## List of Errata to

## Massive MIMO Networks: Spectral, Energy, and Hardware Efficiency

Updated: January 13, 2019.

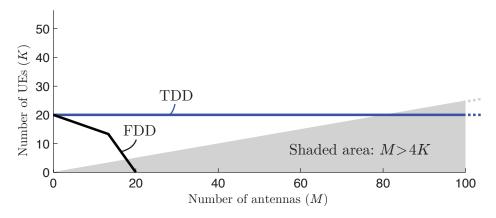
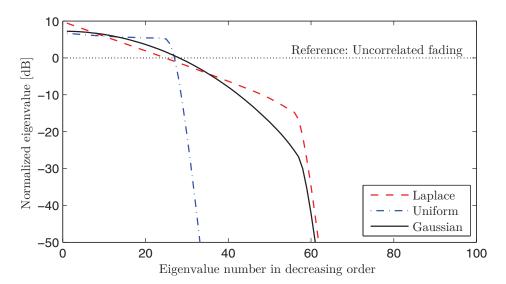
- 1. In the paragraph before Eq. (1.23), "horizontal ULA with antenna spacing  $d_{\rm H}$ " should be "horizontal ULA with antenna spacing  $d_{\rm H} \in (0, 0.5]$ ".
- 2. In Section 1.3.5, the statement "the same as that of sending M additional UL pilot signals" is only true if  $M \geq K$ . To make it more accurate, the statement should instead be "the same as that of sending  $\max(M,K)$  additional UL pilot signals" and the following sentence should be added to the footnote on the same page: "More precisely, with the multiplexing gain  $\min(M,K)$  of SDMA, we need  $\max(M,K)$  symbol transmissions to feed back the MK channel coefficients."

Consequently, the average pilot overhead of the FDD protocol is  $\frac{M+K+\max(M,K)}{2}$  and not  $M+\frac{K}{2}$  (which is only correct for  $M \geq K$ ). This error is found at several places in this section. Moreover, Figure 1.22 is shown as

but should be

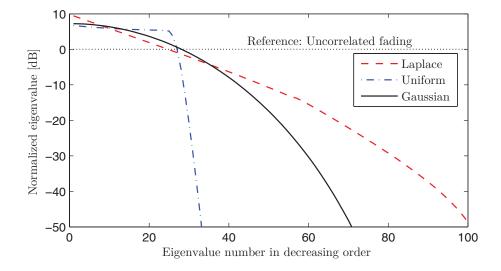
- 3. In Eq. (2.17), the final expression  $\frac{\operatorname{tr}\left(\left(\mathbf{R}_{jk}^{j}\right)^{2}\right)}{(M_{j}\beta_{lk}^{j})^{2}}$  should be  $\frac{\operatorname{tr}\left(\left(\mathbf{R}_{jk}^{j}\right)^{2}\right)}{(M_{j}\beta_{jk}^{j})^{2}}$ .
- 4. Figure 2.6 is shown as

This error was a consequence of insufficient accuracy in the computation of the covariance matrices. The related sentence

"In fact, a uniform angular distribution makes 66% of the eigenvalues  $50\,\mathrm{dB}$  smaller than in the reference case, while this happens for around 40% of the eigenvalues with Gaussian and Laplace distributions."

but should be

should read as

"In fact, a uniform angular distribution makes 68% of the eigenvalues  $30\,\mathrm{dB}$  smaller than in the reference case, while this happens for 40% of the eigenvalues with Gaussian distribution and 19% with Laplace distribution."

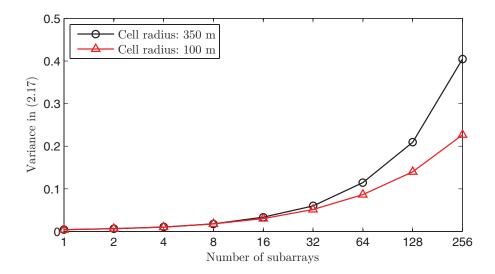
- 12. Figure 7.26 is shown as
